MEMORANDUM

SUBJECT: Site Plan Approval – 400 Washington Street

DATE: August 28, 2025

Request: Site Plan Approval to construct an approximately 8,600 SF office building and associated site improvements, and a Special Use Permit to establish an accessory Drive-Through use at 400 Washington Street, Parcel Number 8-47-106.200.

SITE PLAN

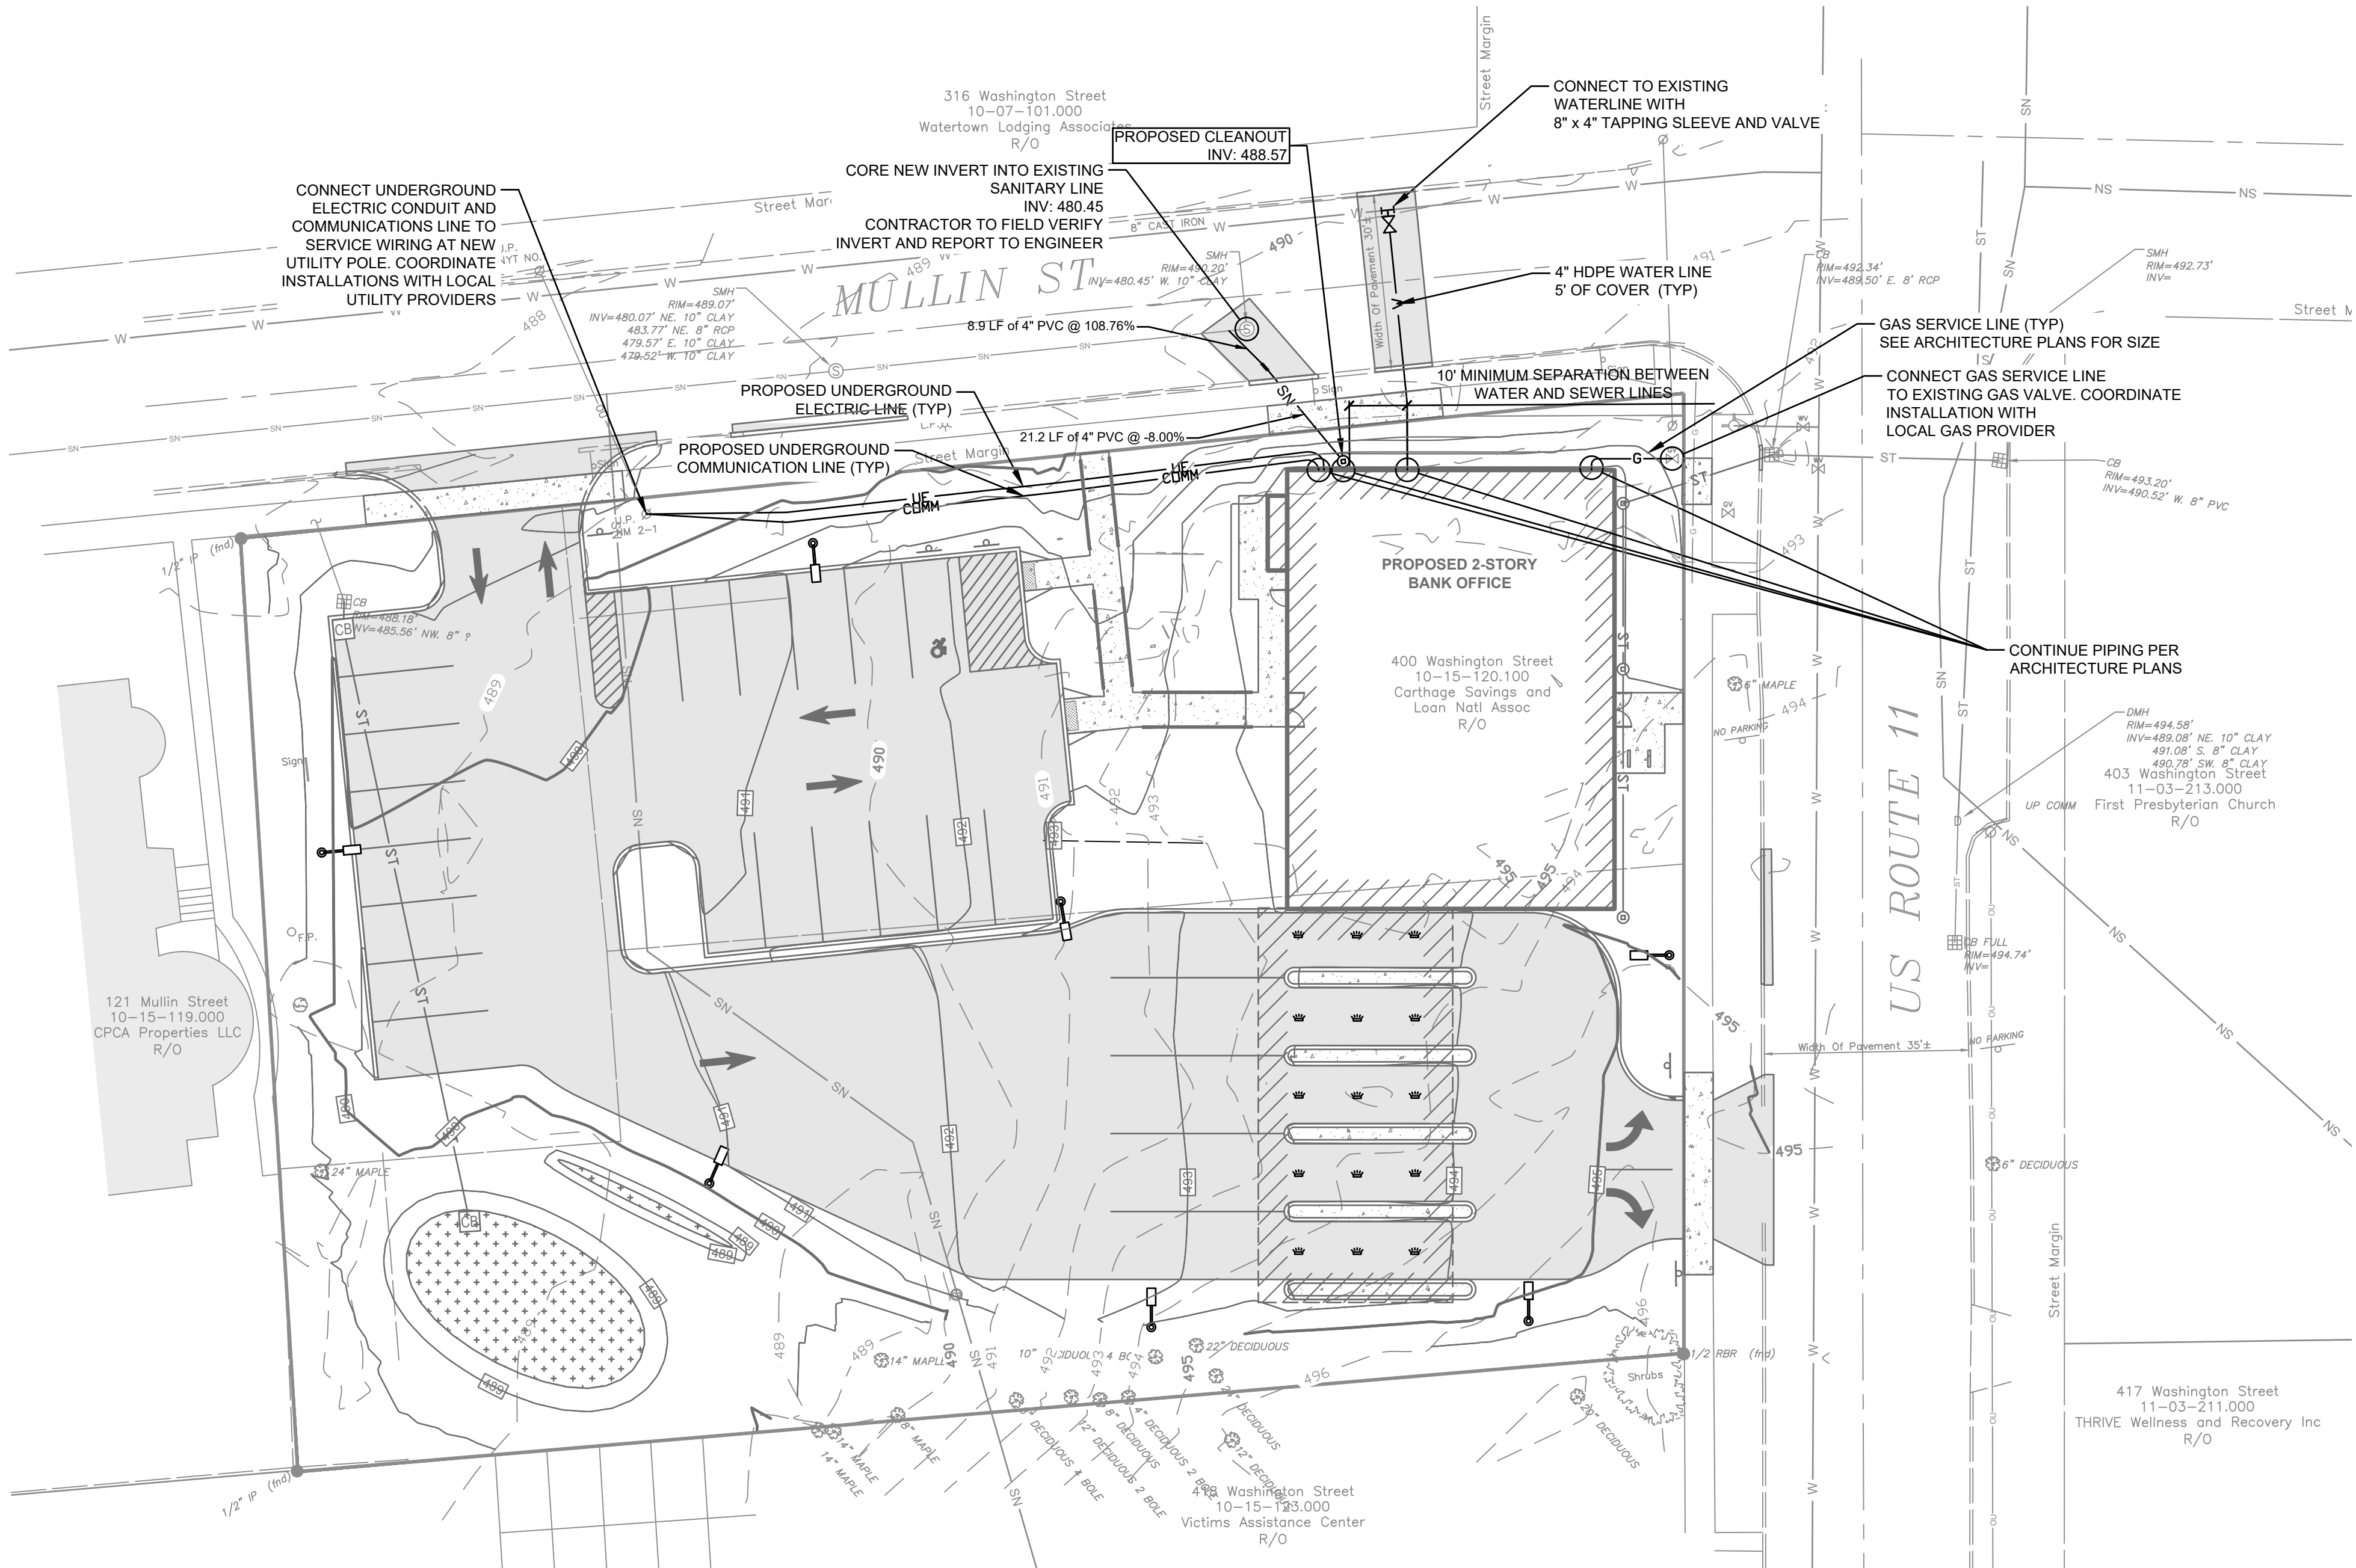
During a recent site visit, Staff attempted to exit the site in a vehicle by turning left onto Washington Street. Over the course of several minutes, there was never a sufficient gap in Washington Street traffic to execute a left turn safely. Staff recommends that the Planning Commission require the applicant to conduct a traffic study to validate the success of the proposed left turn lane.

A high-profile vehicle stopped in the left-turn lane will block the view of southbound traffic on Washington Street (and southbound pedestrians on the sidewalk) from the view of a motorist in the right-turn lane. Multiple vehicles attempting a left-turn exit also creates the potential for significant internal stacking. If a traffic study reveals that a left-turn lane is likely to fail, the applicant should remove it from the plans.

Finally, while the applicant proposes a stop sign on a breakaway signpost where the drive-through exit crosses the Washington Street sidewalk, the applicant should also paint a stop bar on the internal side of the exit aisle to emphasize to exiting motorists that pedestrians have the right of way. This should be added to the plans regardless of the results of the traffic study.

5. The applicant shall add a painted and labeled stop bar to the plans in addition to the breakaway stop sign at the point where the drive-through exit lane crosses the Washington Street sidewalk.

GRADING AND DRAINAGE PLAN
CARTHAGE SAVINGS AND LOAN NEW WATERTOWN BRANCH
400 WASHINGTON STREET
CITY OF WATERTOWN, JEFFERSON COUNT, STATE OF NEW YORK

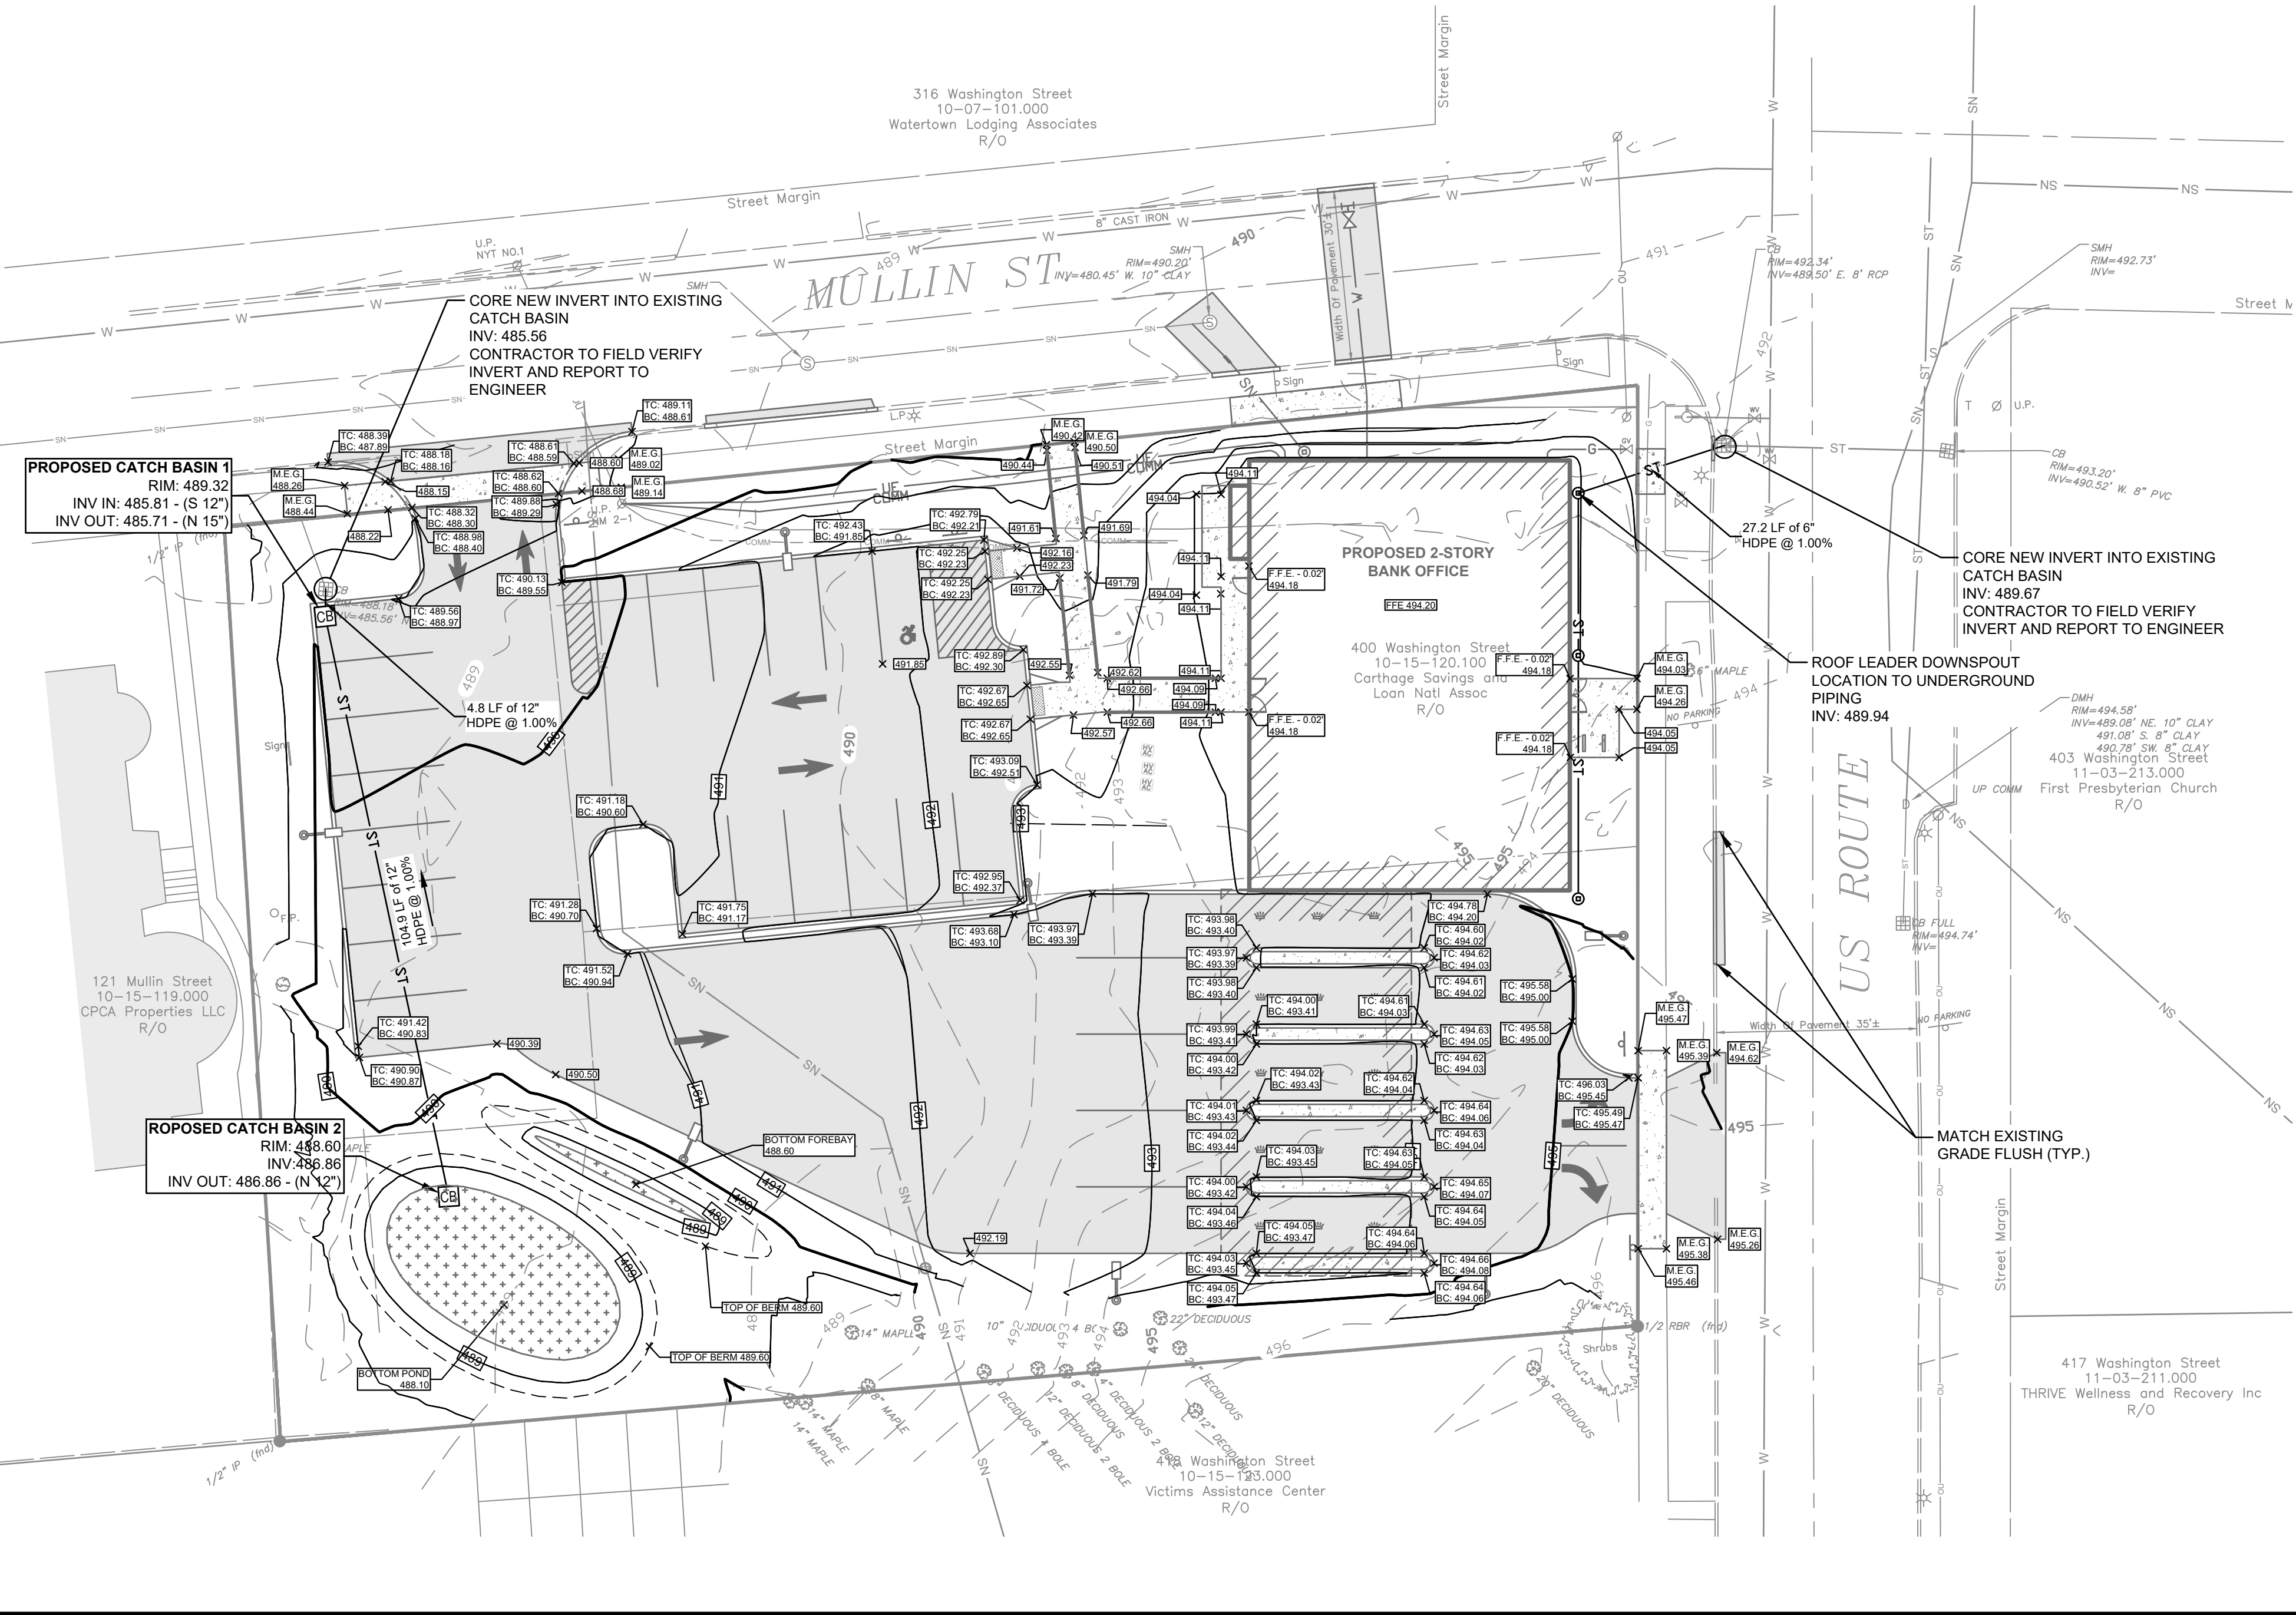
The addition of the bio-retention area is a solution for drainage from the parking lot and the parking lot on the adjoining property. Tying into the storm sewer system should optimize the function of the retention area. Drainage features of this type that are not maintained properly are susceptible to weed trees growing and interfering with the runoff diversion. The bio-retention area should be mowed down at least once a year, in the fall, to prevent this from happening. The Planning Commission should consider making this a condition of Site Plan Approval.

Stormwater and Drainage: Section 4.3 in the Engineering Report refers to a reduction in impervious area and that this “*should* result in a reduction of the peak runoff...” This should be validated. The discharge pipe size from the proposed CB #1 on the grading and drainage plan shall not exceed the size of the existing discharge pipe of the existing CB. The applicant must confirm this pipe discharge.
